We would like to express our thanks for the positive comments and the valuable questions/suggestions on our manuscript. We have revised the manuscript thoroughly based on all the comments. The reviewer's comments are enumerated. Our replies to each comment start with "Response."

Editor's Comment

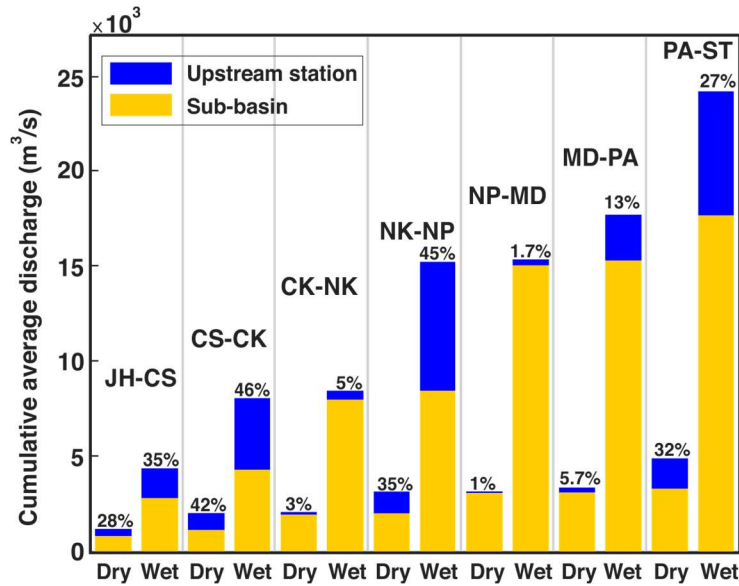
4) In Figure 7 it is recommended to increase the length of the y-axis. Currently PA-ST is covered by the dark bar. I also noticed that the spacing of the DRY WET labels at the bottom is uneven. Although I am not against using tools such as PS to improve the image, it is advisable to consider the overall aesthetics of the image.

Response: Thank you for bringing this issue to our attention. We have adjusted the spacing between labels and increased the length of the y-axis to enhance the visualization of labels and percentages for the PA-ST sub-basin. Thank you for your feedback.

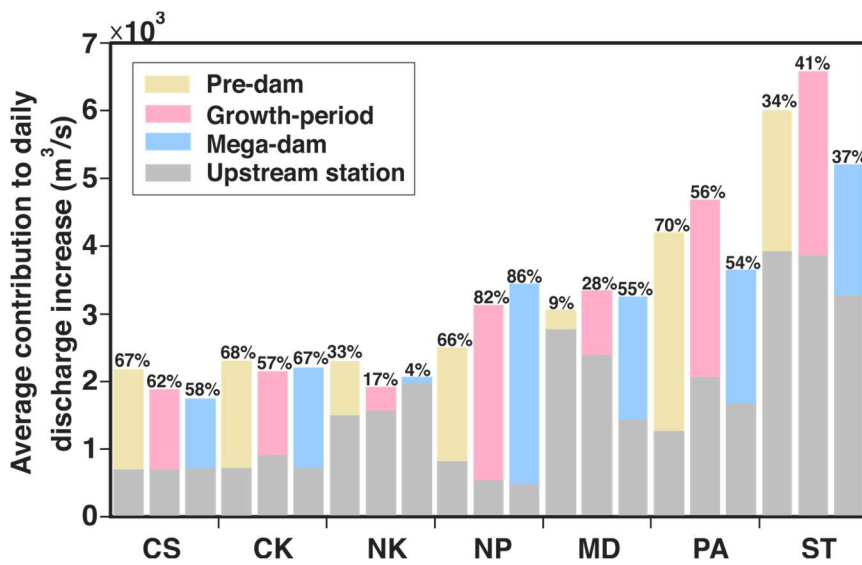
5) In Figure 8 it is recommended to mark the numbers at the top of the BAR and display them in the centre. The current display effect may mislead people into thinking that the digital labels only represent the impact of the dam, without considering the impact of the upstream reservoir.

Response: Thank you for your suggestion. We have moved all numbers to the top and center of the bars for improved clarity. As we highlighted in various sections of the paper and in the caption for Figure 8, the percentages represent the contribution of each sub-basin to its downstream station. We did not separate the impacts of dams and precipitation for each sub-basin (see lines 449 to 454). Additionally, as mentioned in Section 3.1.2, our objective is to conduct a regional contribution analysis. In Section 2.3, we provide definitions for each period, which refer to human activities such as dam construction, land cover changes, and irrigation projects.
